**PC 22 04 DR 05 & AR 22 11 SIR 06
Supplemental Findings—Exhibit A1**

TITLE 10 CHAPTER 6: DESIGN REVIEW

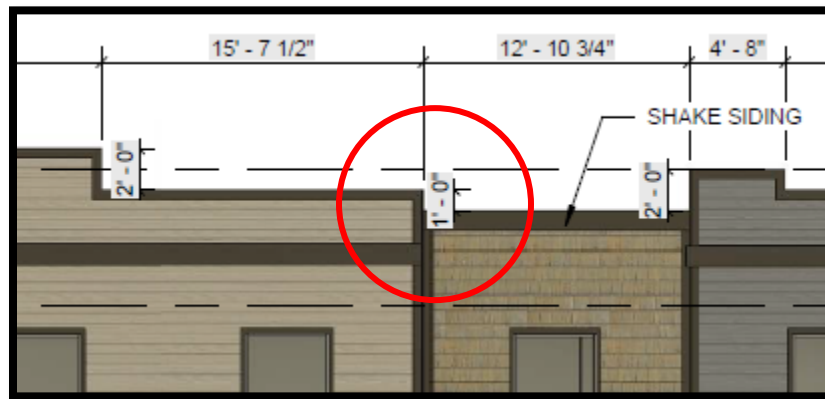
The west side of the hotel façade fronts Quince St. Shake siding is used within two recessed areas located along the northern half of the west side of the building, contrasted also by 4" lap siding, trim and windows. The recesses do not meet the criterion as they contain a depth of 3 feet. They can however be classified as a "break" in "d" on the next page. Criterion not met.

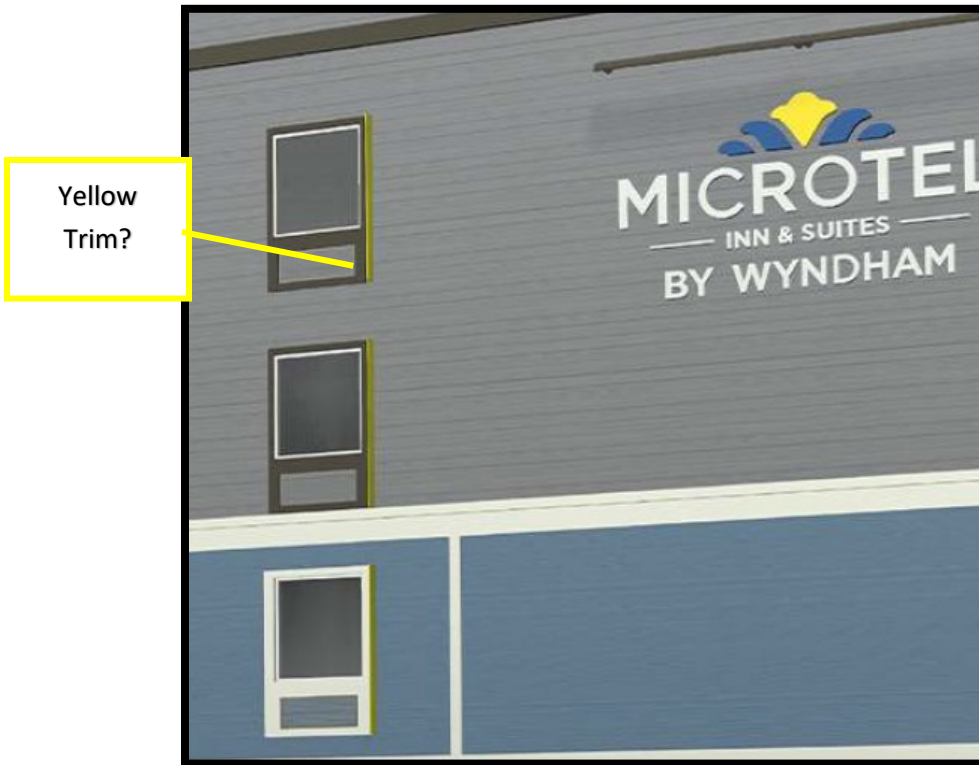
To date, there is no proposal to install landscape/retaining walls. The applicant may choose to propose these with submittal of the final landscaping and irrigation plan, which has been conditioned in these findings. Fencing has been proposed around the stormwater facility located on the north side of the property, the trash receptacle enclosure at the northeastern side of the hotel (which has been conditioned), and the condensation units at the east side of the hotel. The fencing materials for these elements are of those listed above. The fencing for these elements is discussed elsewhere in these Findings.
